SERVICE BULLETIN AMATEUR RADIO

SUBJECT TS-950SD SPEECH PROCESSOR NOISE	DATE 01/12/90
---	-------------------------

THE FOLLOWING WILL BE PERFORMED ON THE FOIL SIDE OF THE SIGNAL BOARD.

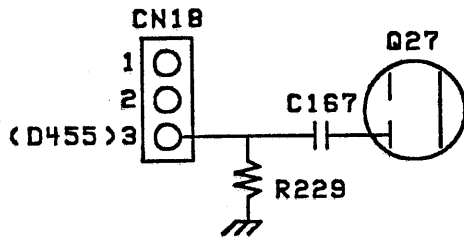
When the Processor-In control is set to some level below 10dB of compression, a crackling noise can be induced on the transmit signal. The following modification will reduce the noise. After the modification has been performed, the noise can only be heard when the Processor-In control is set too low to be functional.

1. Cut the foil between pin 3 of CN18 and chip resistor R229.
2. Desolder and remove R229.
3. Solder a 10 ohm chip resistor across the cut foil.
4. Solder a 39 ohm chip resistor in place of R229 (it will be slightly offset due to the installation of the 10 ohm resistor).
